ADDENDUM NO. 1

PROJECT NAME: NE Soccer & Tennis Complex- General Construction
UNL PROJECT NUMBER: C909P101/ 10186
BID INVITATION NUMBER: 2339-14-7200

CONSULTANT: RDG Planning & Design
ADDRESS: 301 Grand Avenue
Des Moines, IA 50309

DATE OF ISSUANCE: March 27, 2014
DATE OF BID OPENING: Tuesday, April 8, 2014
3:00 PM CT

A1.13

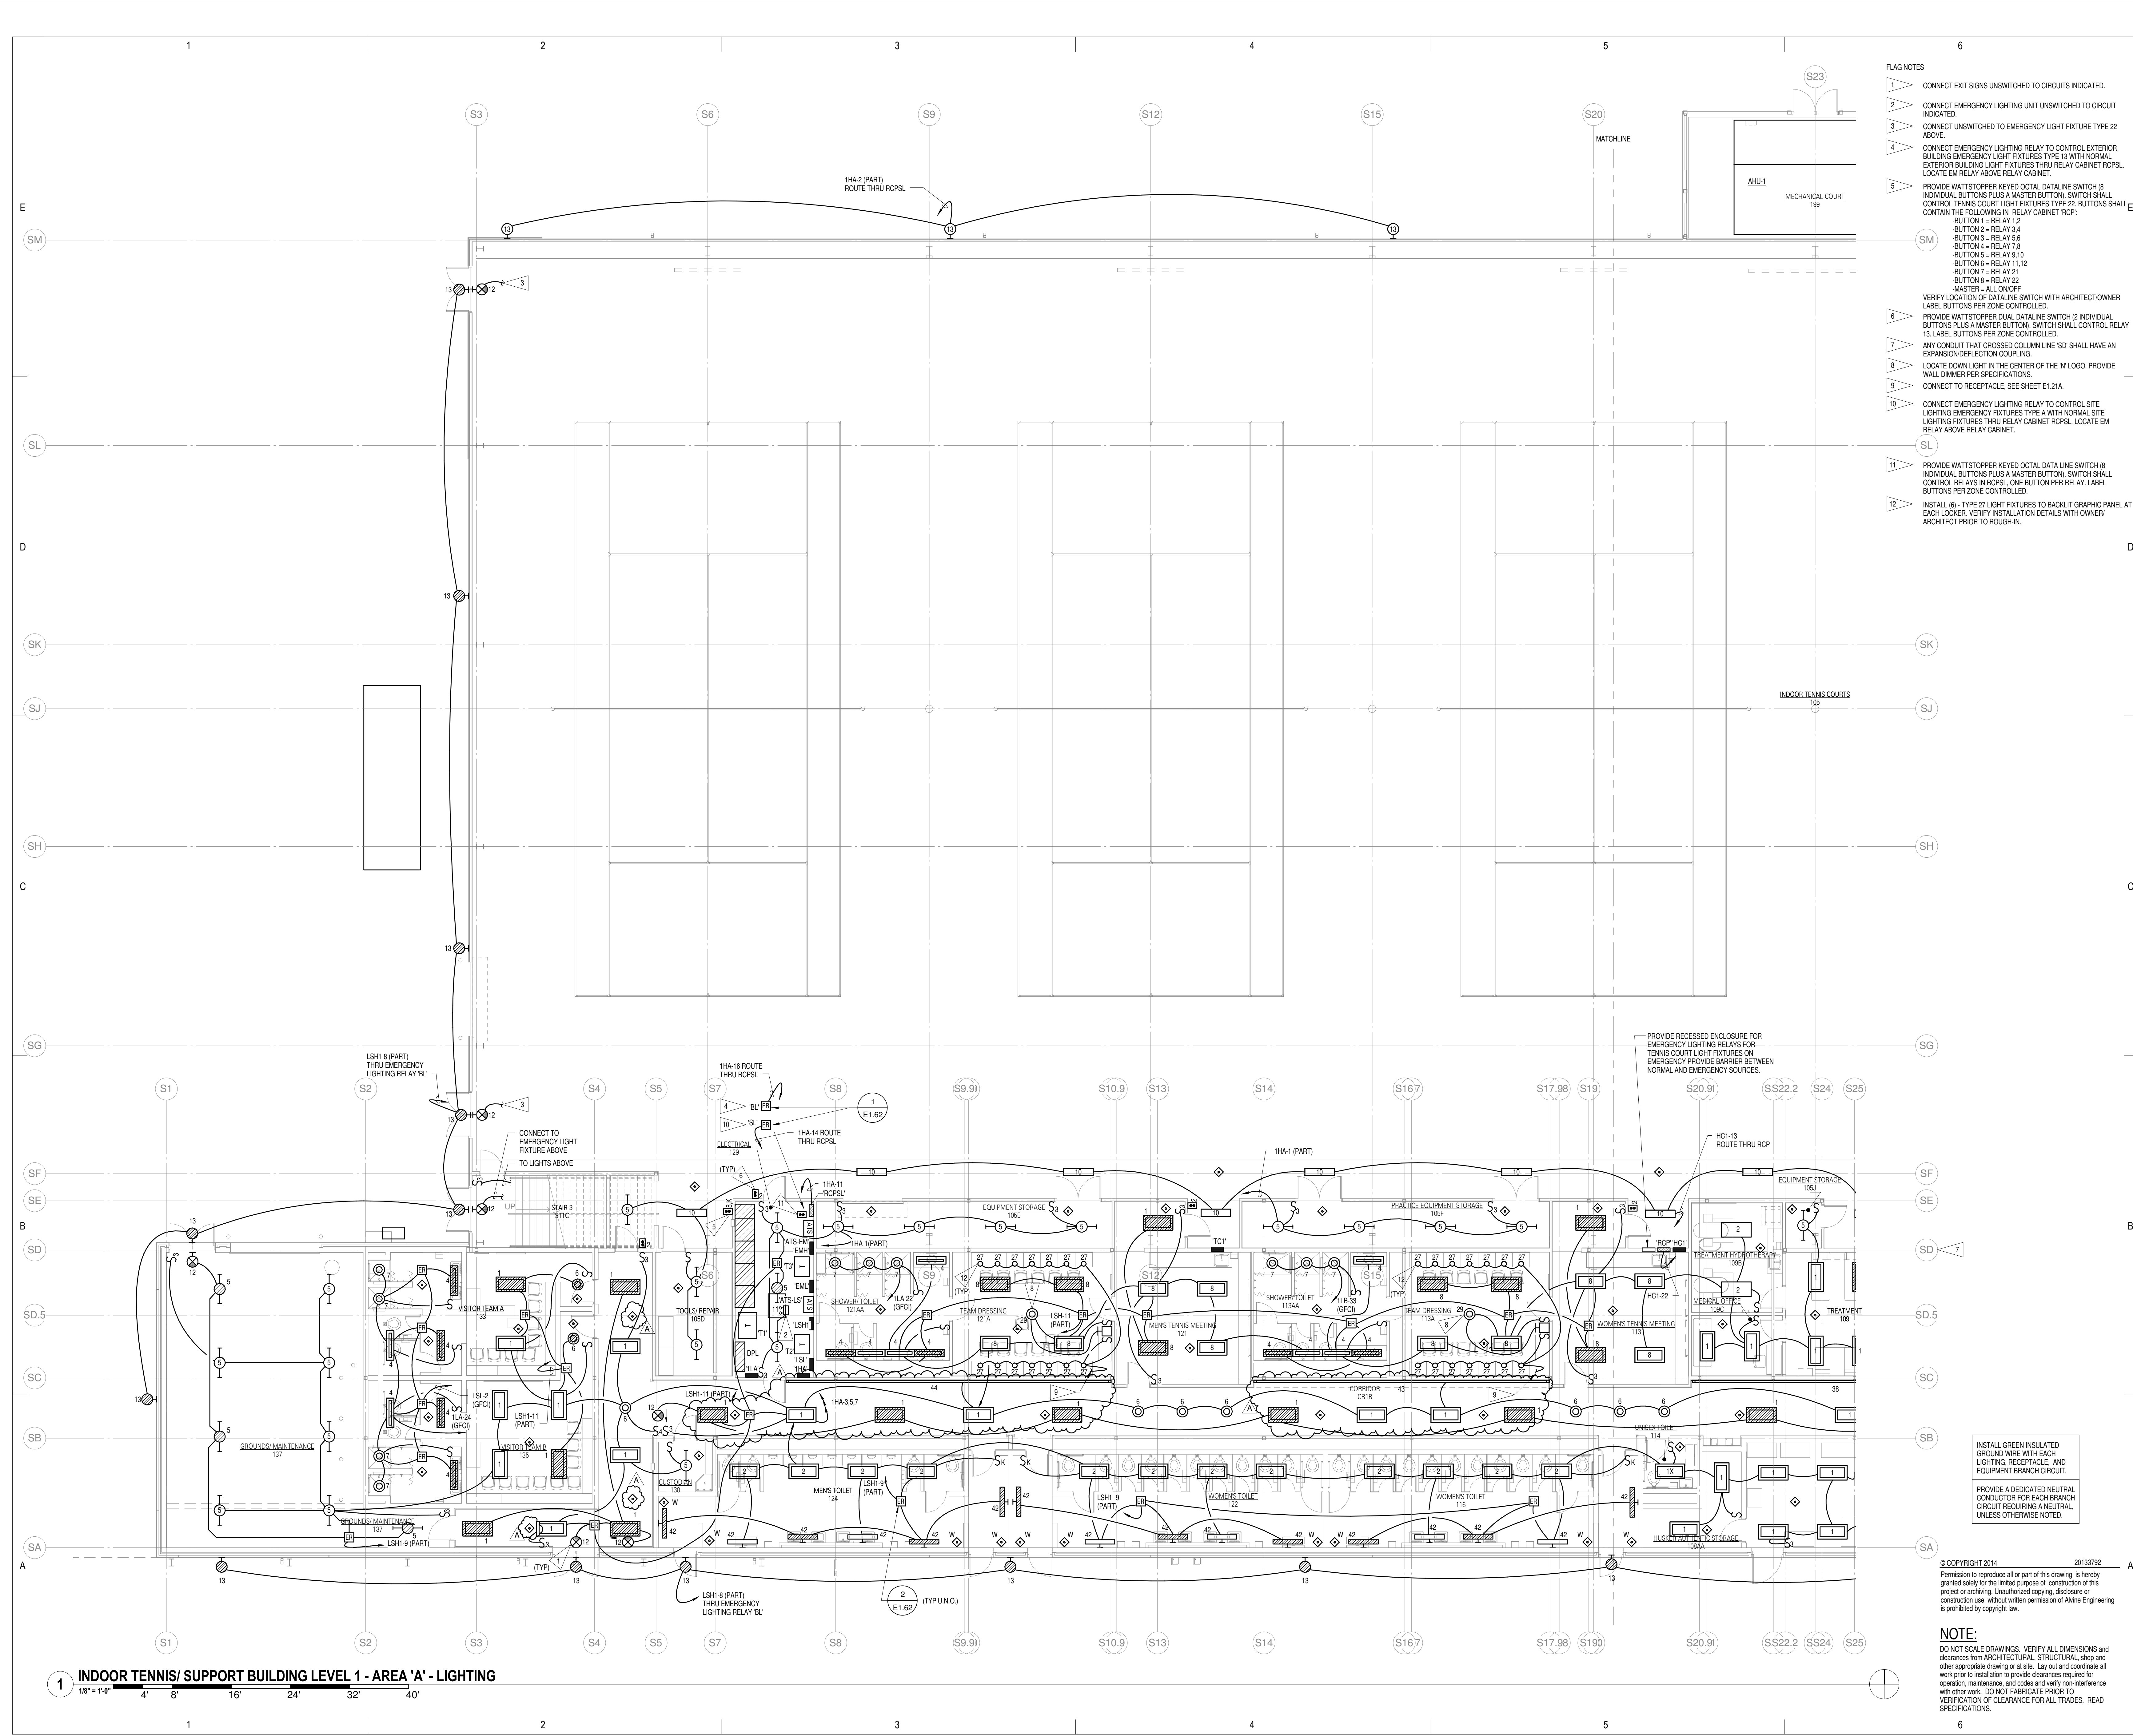
- A. Drawing A2:
1. Indicate roof penetrations. See attached Drawing A1.13.
 2. Indicate revised snow guards as shown on attached Drawing A1.13.
